CITY OF WEST LAKE HILLS, TEXAS
NOTICE OF ZONING & PLANNING COMMISSION (ZAPCO) REGULAR MEETING
Wednesday, October 21, 2020 at 6:30 PM

CITY OF WEST LAKE HILLS, TEXAS
MINUTES OF A ZONING & PLANNING COMMISSION (ZAPCO) REGULAR MEETING
Wednesday, September 16, 2020 at 6:30 PM

Doucet & Associates, Inc. (Doucet), is pleased to submit this response letter to our September 29, 2020 engineering drainage report documenting the analysis of a partial easement release located at 2 Downie Place in West Lake Hills, Texas. Our response to Comments 3-8 are as follows in blue text.

Cross Section 4

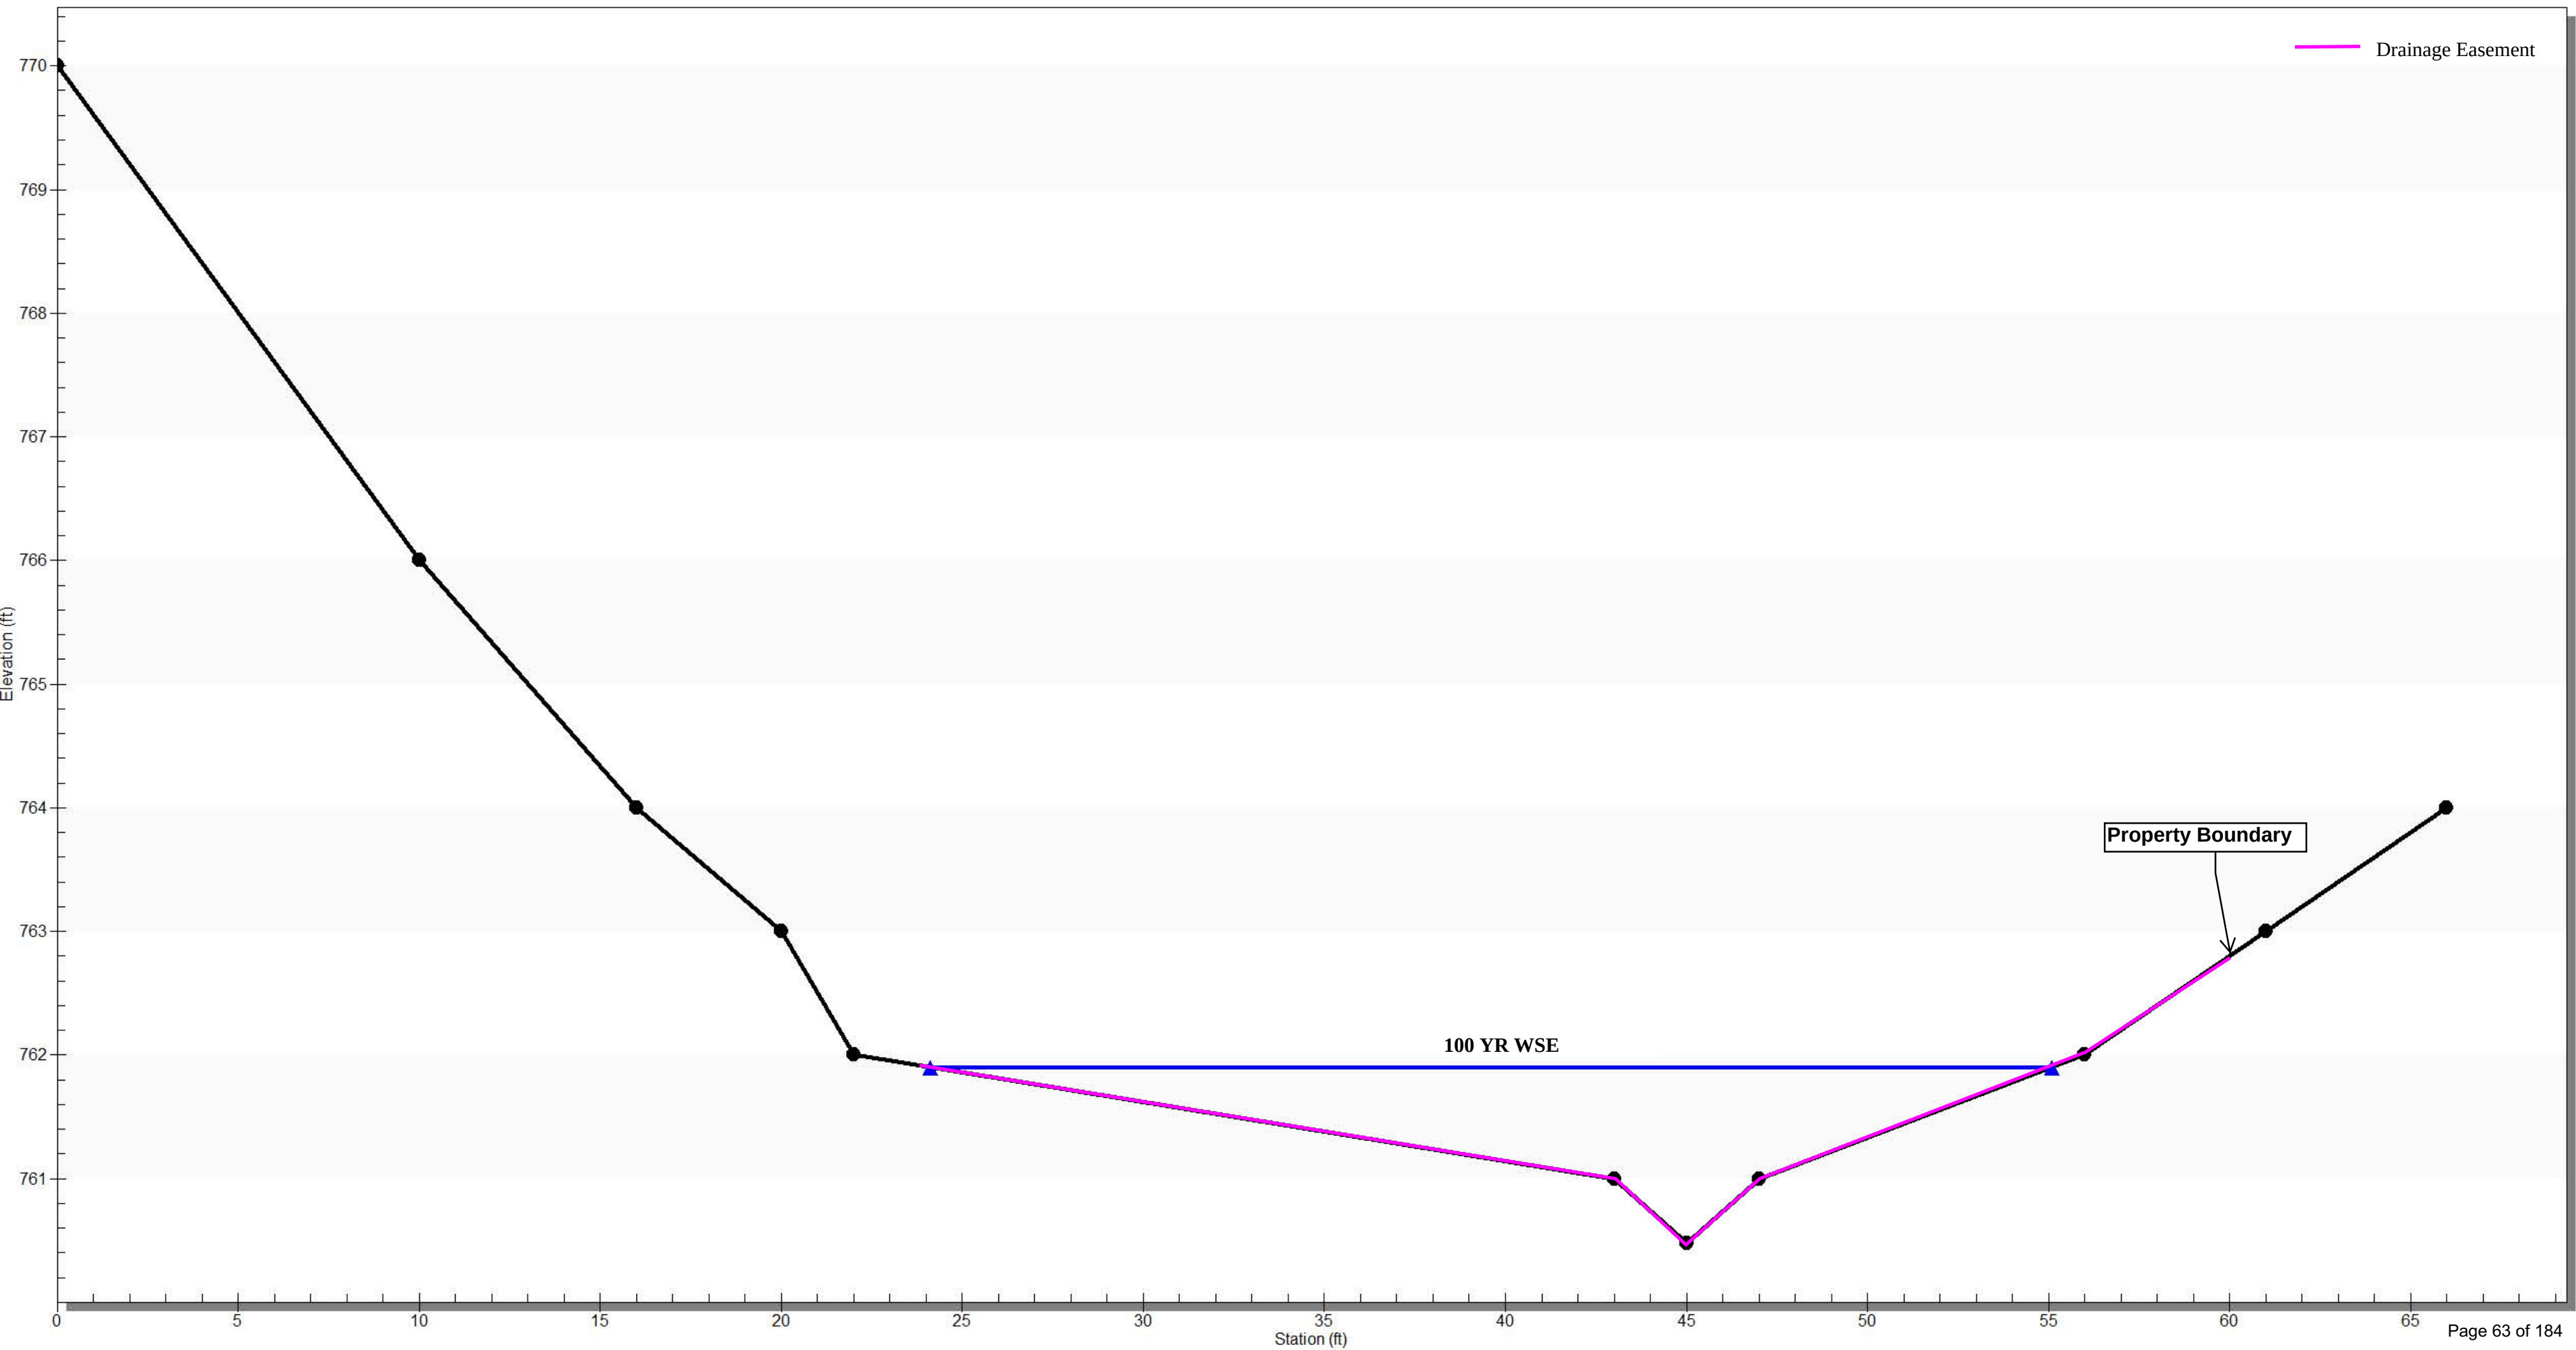
3-C1) Please show property line, existing, and proposed easement line in the cross section to verify overtopping elevations.

7-C1) Please show property line, existing easement line, and proposed easement line in the cross sections.

Response: Easement lines and property boundary has been added to cross sections.

Response: Easement lines and property boundary has been added to cross sections.
